FORT WAYNE COMMUNITY SCHOOLS 2025 GENERAL BUILDING SYSTEMS 2 (GBS2) – FOREST PARK, FRANKE PARK,

Addendum No. 01

February 10, 2025

Project No. 24047

ALTERNATE NO. 01
 PARTIAL WALL SECTION
 15 $\frac{3}{4}'' = 1'-0''$

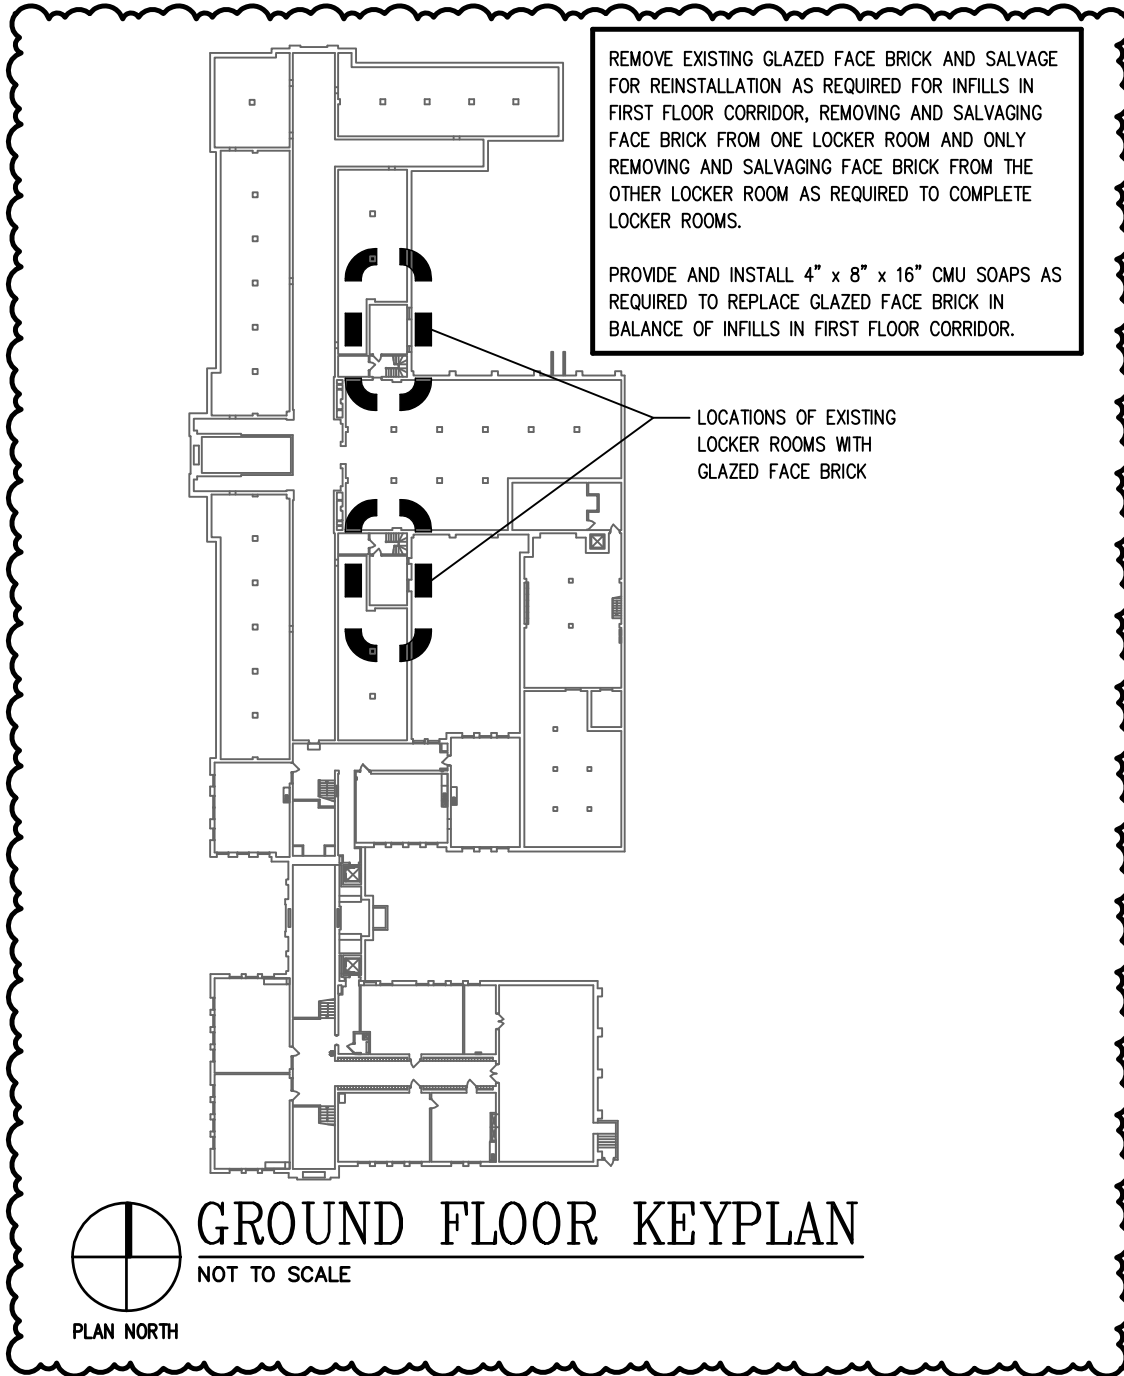
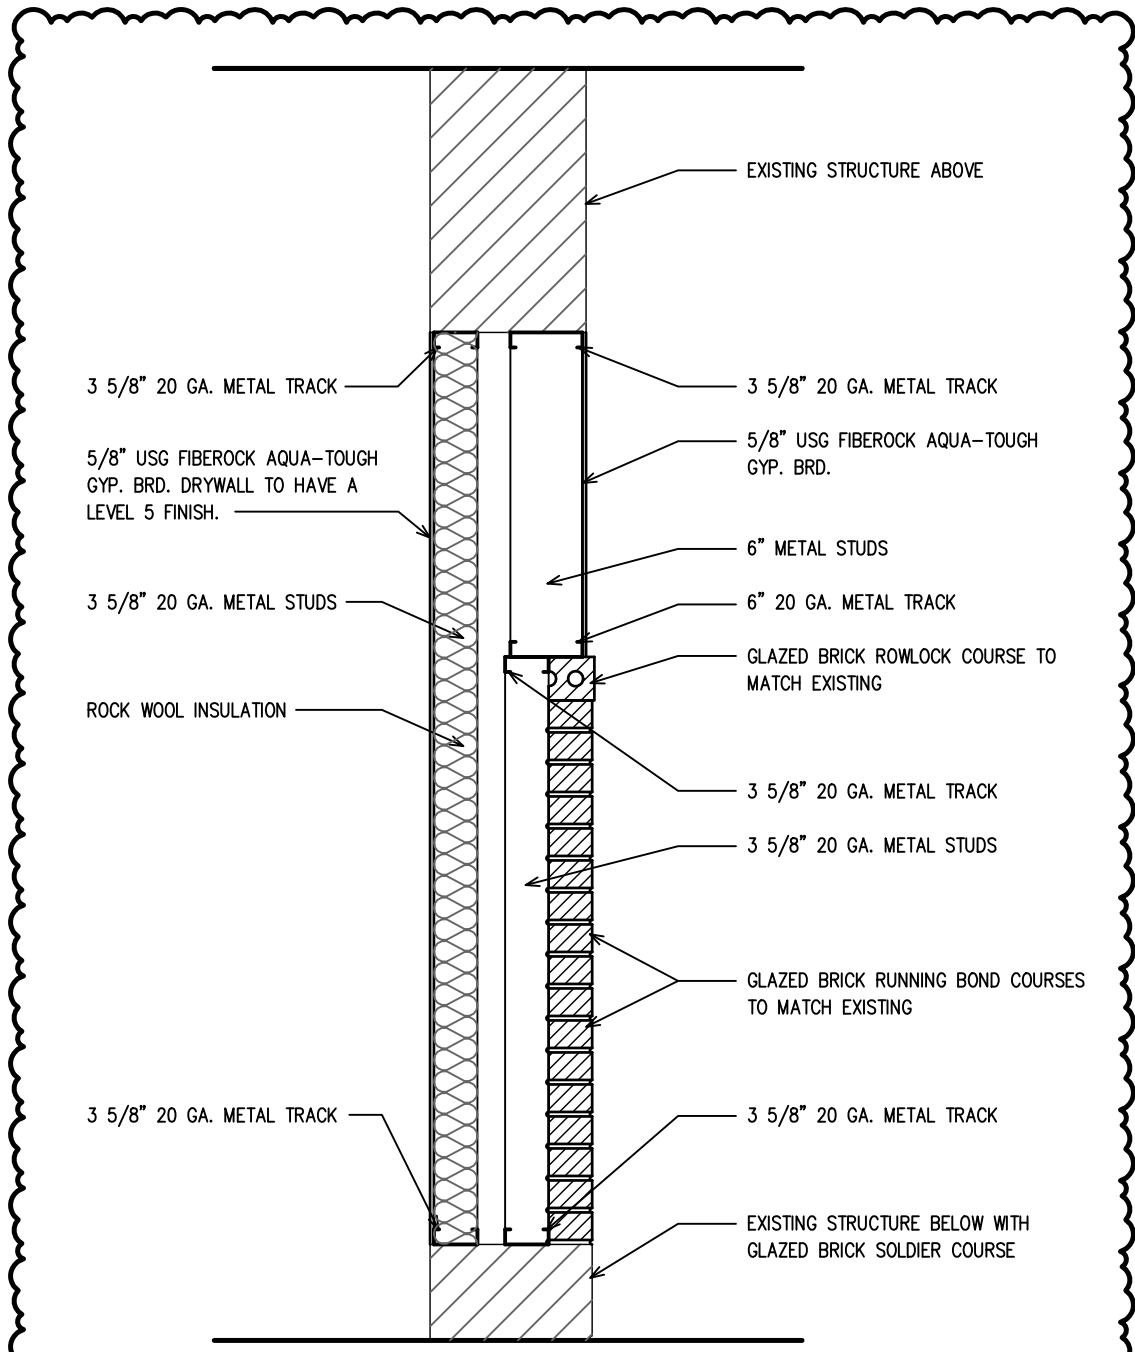
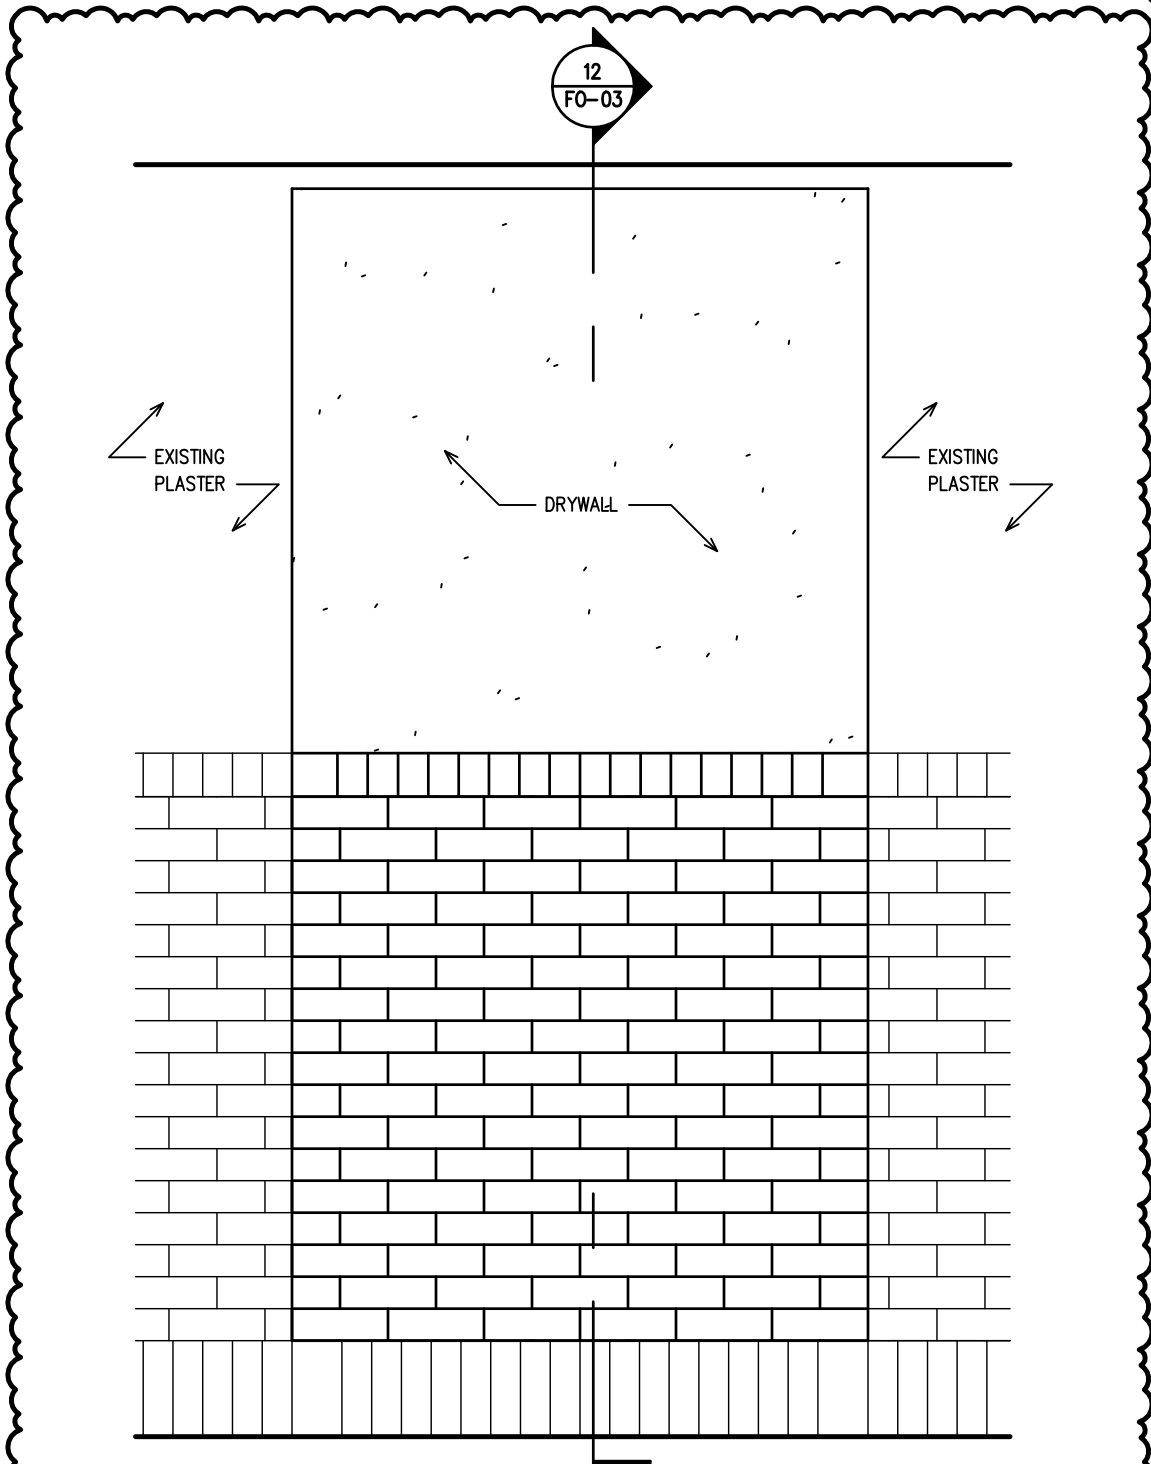
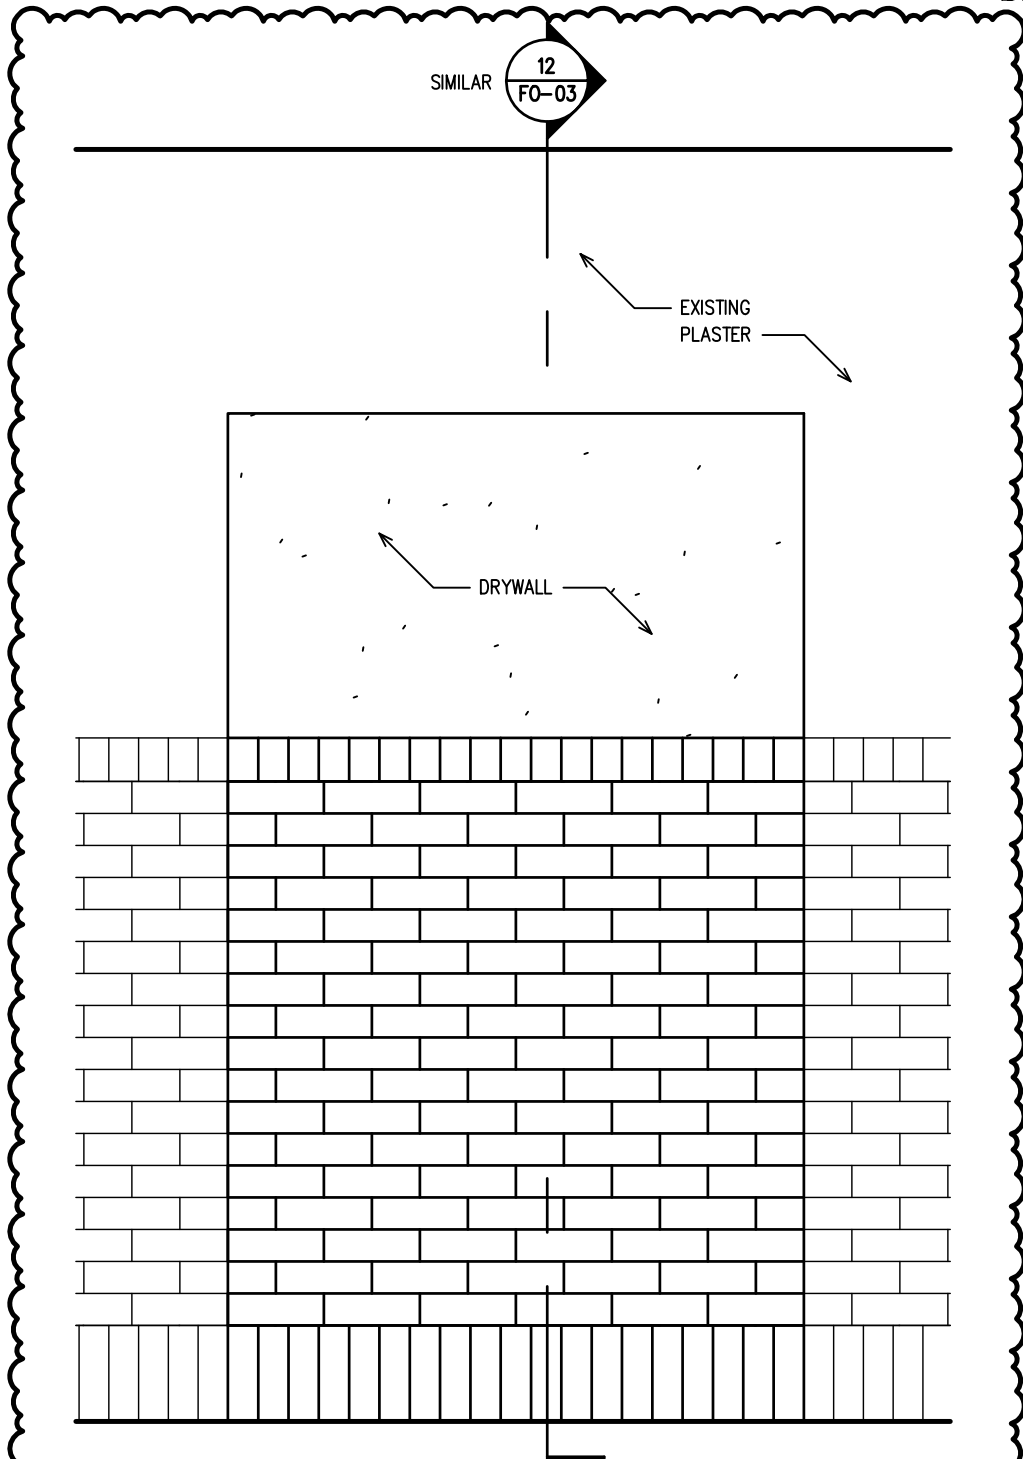
Replace details as shown. **See Attachments 07 – 09.**
 5. Add Ground Floor Keyplan as shown. **See Attachment 10.**
 6. Add Details 15 – 17 as shown. **See Attachments 11 – 13.**
- e. **Sheet FO-04:**
 1. Door Schedule: Make the following changes and/or corrections:

Drawing FO-P2.0

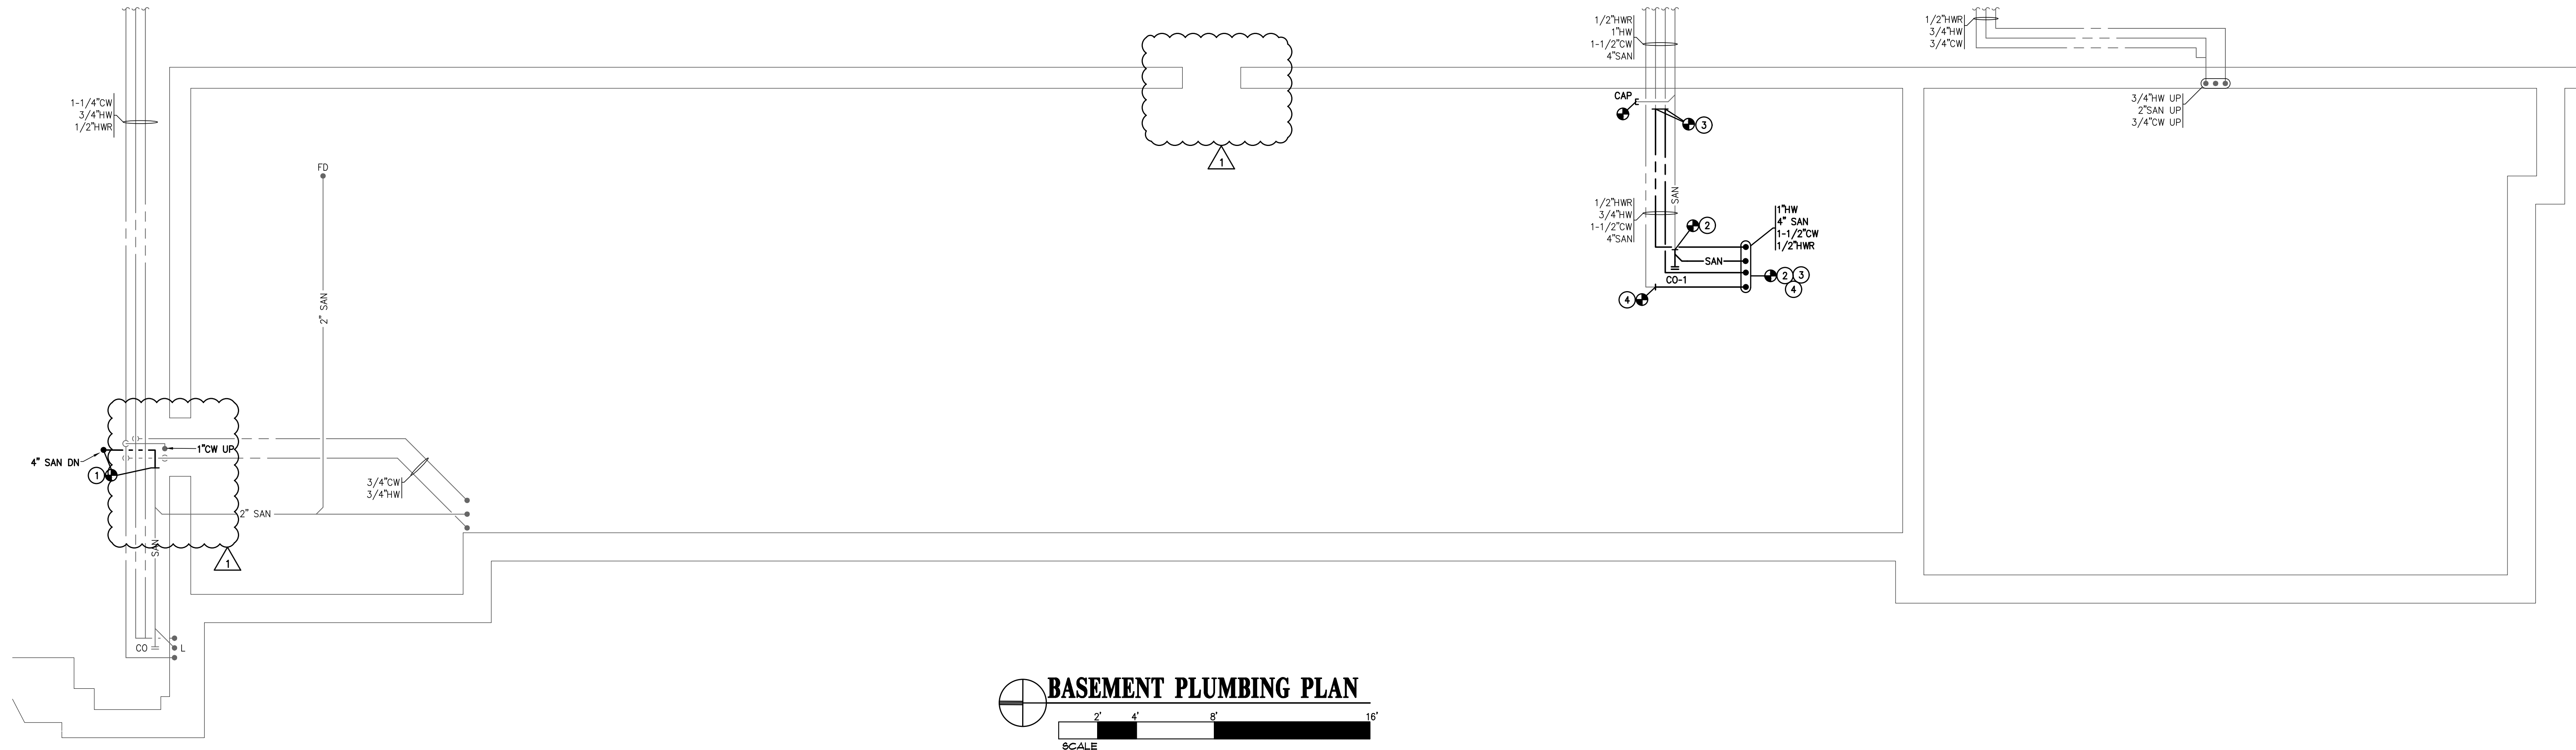
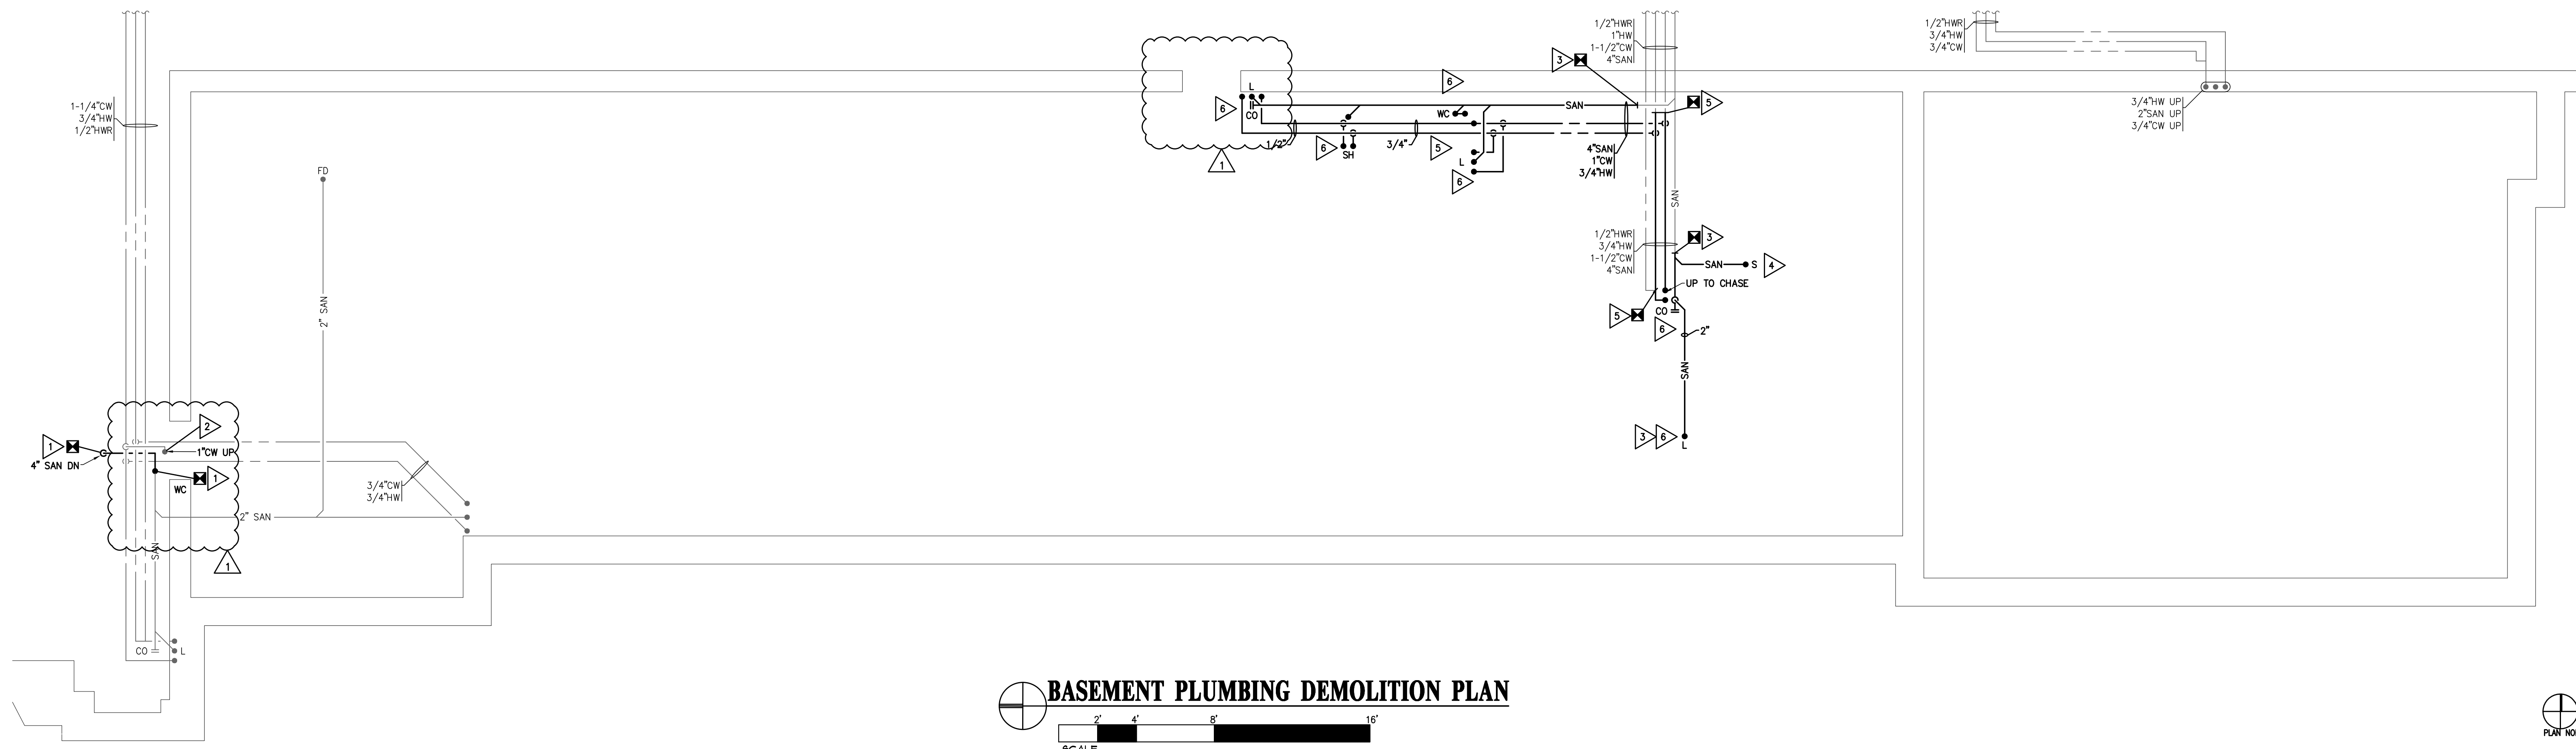
1. Contractor shall reference sheet for access points located within basement, per owner review.
